## Notes of 2/15 MMC Site Plan Review Meeting (CMP/Detours)

## MMC TDM PLAN | City Review Comments 1/24/18 (Tom Errico, Bruce Hyman, Nell Donaldson)

<b>TO:</b>	Jean Fraser, Planner	<b>DATE:</b>	1/25/2018
<b>FROM:</b>	Michael Guethle, PE; Ryan Wingard, PE	<b>PROJECT NO.:</b>	13982A
<b>SUBJECT:</b>	Bramhall St. - 22; MMC East Tower and Visiting Parking (PEZ.2017.289)

TO: City of Portland – Planning Board  
 FROM: Jim D. Wentworth, P.E.  
 DATE : February 21st, 2018  
 SUBJECT: Maine Medical Center – Constructability Review

FIGURE 6

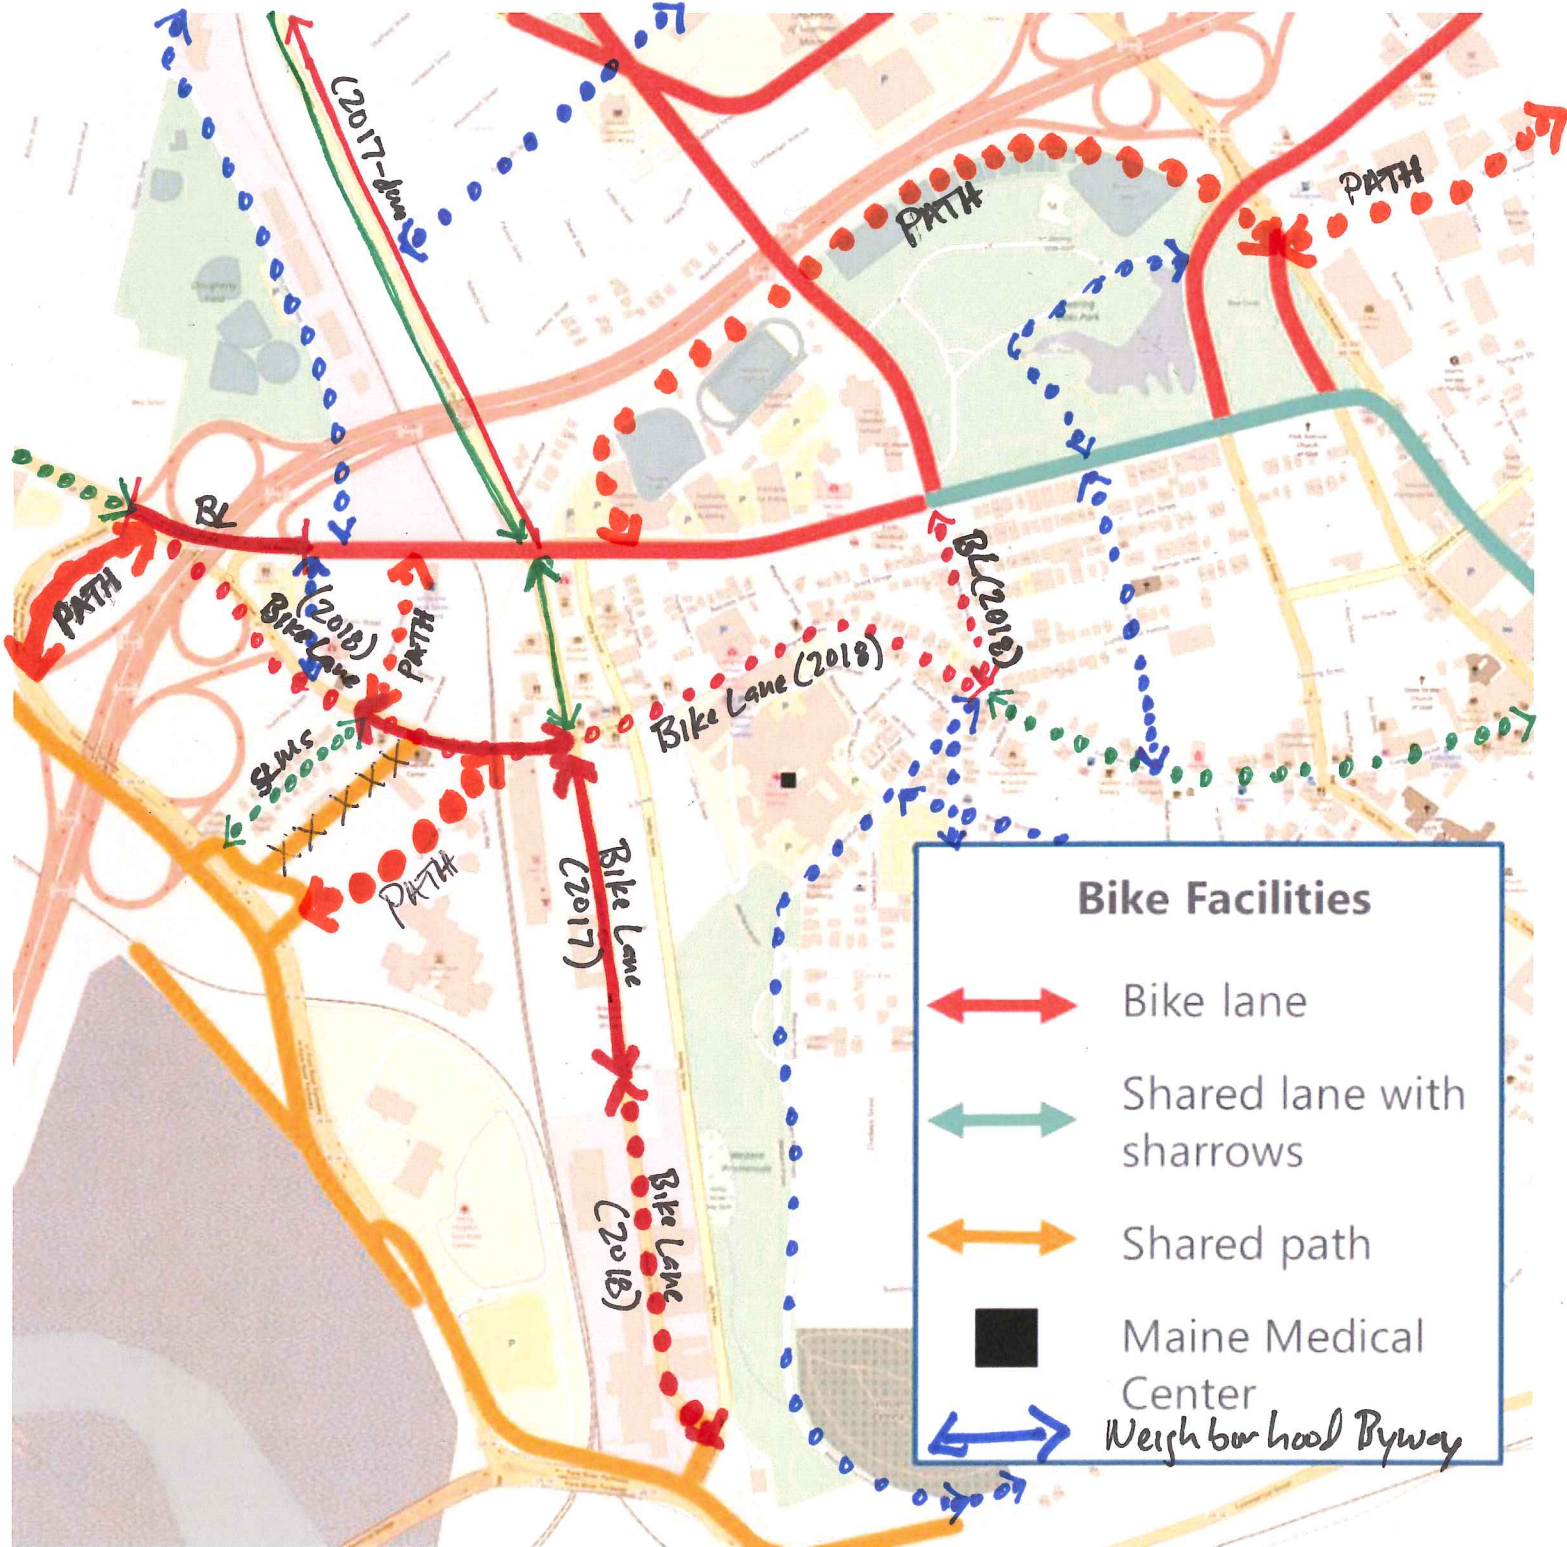
- Figure 6 should include both the existing and proposed bike network (see attached markup).
- The TDM plan notes that vanpool and carpool vehicles will get preferential parking spaces in the new employee garage. The location of the new garage may actually be a barrier for increased carpooling. We would suggest identifying spaces on-campus.
- The 'pay for parking' section is in the future tense. This should be in the future strategies section.
- The plan should also clarify the cost for parking – is it \$3 per week or bi-weekly? Paying for parking (and allowing cash out) is potentially one of the most significant things the hospital could do to shift mode share. Fees could/should be increased significantly.
